Staff Report & Recommendation

SUBJECT: HPB19-0353, **1530 Collins Avenue.**

The applicant has submitted plans entitled “Aqua Hotel”, as prepared by Revuelta Architecture International. dated November 12, 2019.

Postcard, postmarked 1957

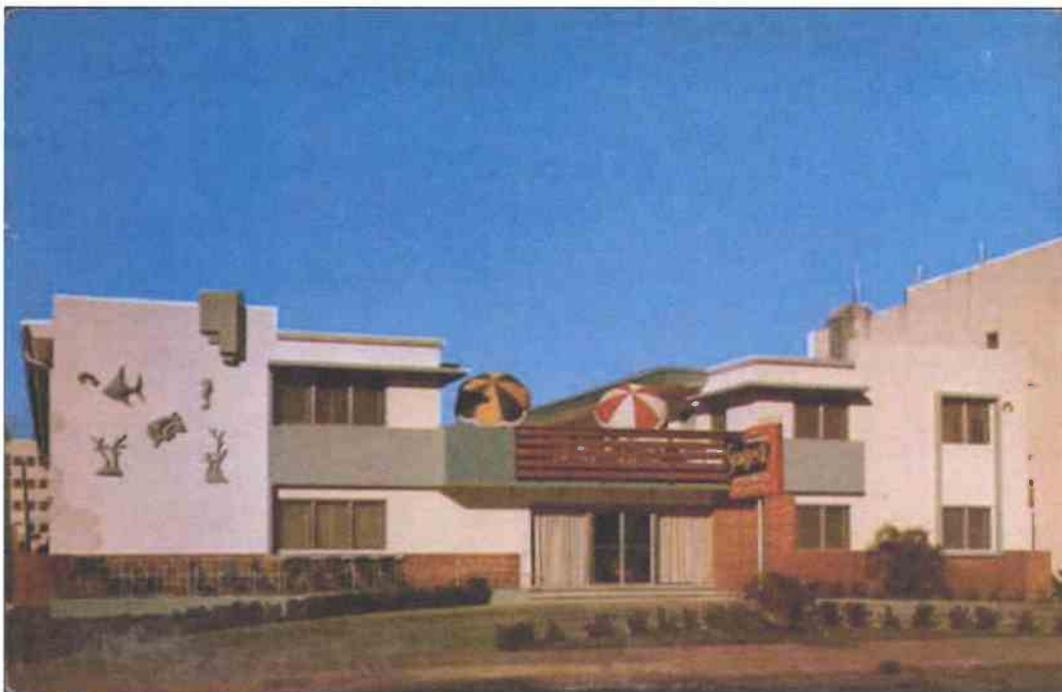
The subject structure, originally known as the Sun Deck Hotel and Apartments, was constructed in 1953 and designed by MacKay & Gibbs in the Post War Modern style of architecture. The plan of this Contributing 2-story garden style building is organized along an east-west axis with catwalks and hotel units facing onto a central interior courtyard. The asymmetrical front façade is set on an angle, following the alignment of Collins Avenue and features a number of significant architectural elements characteristic of the Post War Modern style of architecture.
